TECHNICAL EVALUATION REPORT OF THE ELECTRICAL,
INSTRUMENTATION AND CONTROL FEATURES OF PROPOSED
HPCI AND ESAP MODIFICATIONS OF THE DRESDEN NUCLEAR
STATION, UNIT 1

TECHNICAL EVALUATION REPORT
ELECTRICAL, INSTRUMENTATION, AND CONTROL FEATURES OF PROPOSED
HPCI AND ESAP MODIFICATIONS

DRESDEN NUCLEAR STATION, UNIT 1

Docket No. 50-10

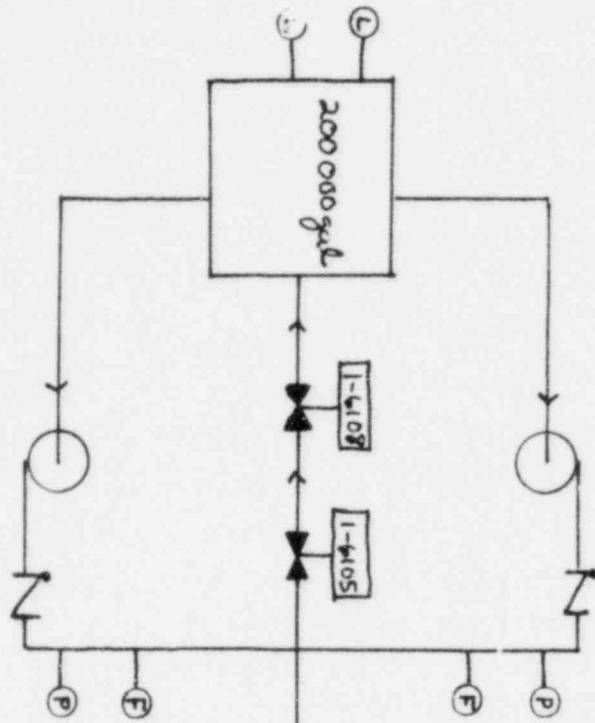
Separation of non-essential 4160 V buses from the ESAP 4160 V buses occurs by tripping the feed breaker on bus 12 (11), which normally feed bus 110 (112) and the transformer for bus 15 (16). However, control power for these breakers comes from a common source and is, therefore, susceptible to single failure. Commonwealth Edison has committed to install redundant trip coils powered from redundant Class 1E sources in these breakers to ensure that the separation feature is not susceptible to single failure. Provided that adequate physical separation is maintained between the proposed additional trip coils and the existing control circuitry, this measure would provide for the required bus separation.

Separation of ESAP 480 V buses and non-essential 480 V buses occurs by tripping the tie breaker between buses 15 and 14 (16 and 17). These breakers are normally open but will trip open if closed when power to bus 15 (16) is not being supplied from offsite power. However, these breakers have a common control power source and are, therefore, susceptible to single failures which could prevent them from opening to separate ESAP and non-essential buses. This could result in overloading the ESAP diesel generator

or inadvertent paralleling of the ESAP diesel generators through tie breakers which can connect bus 14 and 17 load centers. There are no limiting conditions for operation (LCO) requirements prohibiting closure of these breakers during reactor operation. Therefore, these breakers do not comply with current licensing requirements for independence of redundant onsite emergency power systems.

Manual tie breakers exist which can connect redundant load centers powered by buses 15 and 16. These breakers have no interlocks to prevent paralleling of redundant onsite emergency power sources. There are no LCO requirements prohibiting closure of these breakers during reactor operation. These breakers do not comply with the current licensing requirements for independence of onsite emergency power systems.

3.2.2 Evaluation. The redundant ESAP systems at Dresden 1 meet the requirements for electrical independence, redundancy, capacity, physical separation, and ability to perform with a single failure, with the exception of the tie breakers connecting buses 14 and 15 (16 and 17) and connecting load centers supplied by buses 15 and 16. The breakers connecting buses 14 and 15 and buses 16 and 17 have a common source of control power and are susceptible to single failures which could cause failure of ESAP and non-essential bus separation, and could cause paralleling of redundant sources. The breakers connecting load centers supplied by buses 15 and 16 have no interlocks to prevent paralleling redundant onsite emergency power supplies. There are no LCO requirements prohibiting operation of these breakers during reactor operation.
